ALARM INDICATION E90/E9E OR “NOT POSSIBLE” ON DISPLAY

All Sahara HP2C tumble dryers with serial number up to 310xxxxx.

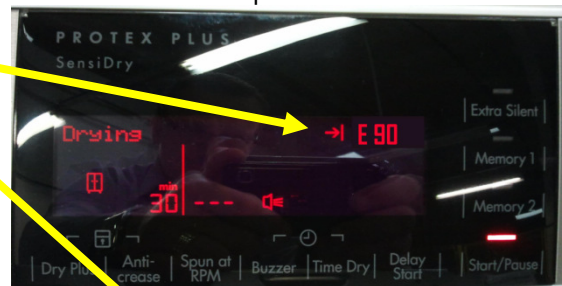
In Tumble Dryer HP2C series 9N alarm code E90 may be displayed in normal operation mode. In diagnostic mode alarm code can change to E9E. This may occur in appliances with serial number up to 310xxxxx. In case of user interface board malfunction, message “Not possible” is displayed during drying cycle.

Normal operation mode

Diagnostic mode

Problem is caused by disturbances present on touch buttons. To solve it, user interface board has to be changed to new one (1366204384).
